**Proposed Temporary Shop and Services with Ancillary Facilities
and Associated Filling of Land for a Period of 5 Years in "Open Space" Zone,
Lot 2882 S.B RP in D.D. 104, Mai Po, Yuen Long, New Territories**

(S.16 Planning Application No. A/YL-MP/393)

Response-to-Comment (RtC)

PHOTO 1

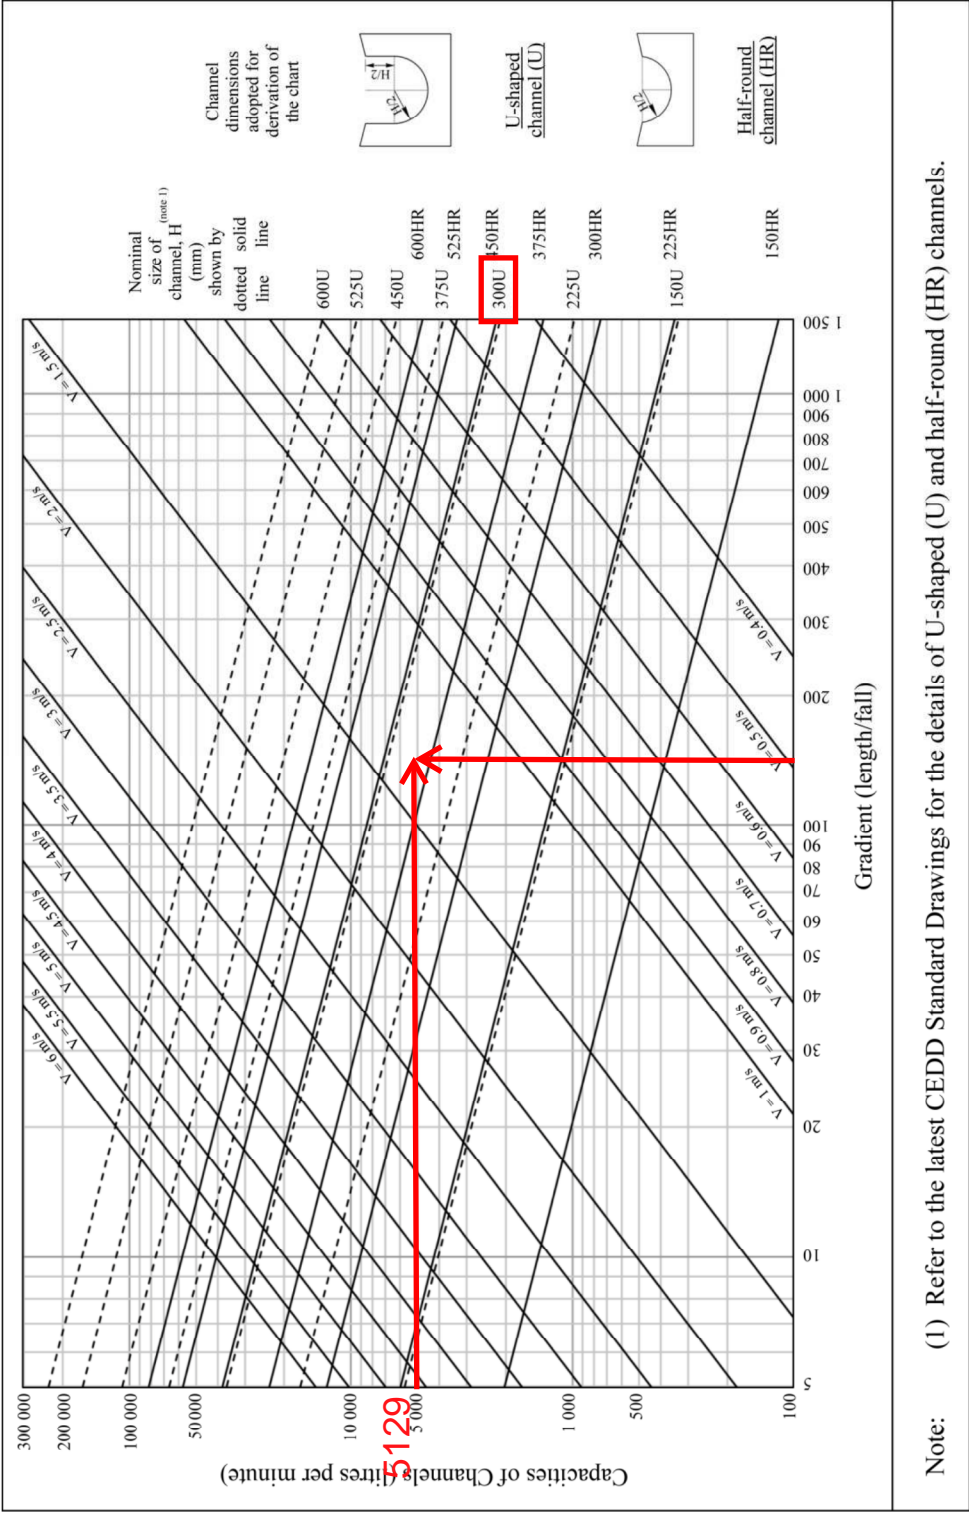
(b)	The condition of existing stream shown in the photo appears blocked with refuse and some overgrown vegetation. The applicant shall clear the blockage to maintain an unobstructed flow.	Noted. All debris in the existing stream shall be cleared as stated in the Note.

(e)	It appears that the downstream site formation level is higher than the Site. Please ensure that the catchment area shown is correct, the levels of the existing stream and the final discharge are lower than the proposed invert level at CP3. Adequate flood protection measures should be considered if the Site is located in a low-lying area, and a flap valve should be installed at CP3 to prevent water backflow into the Site.	The catchment area has been revised. Flap valve is provided.
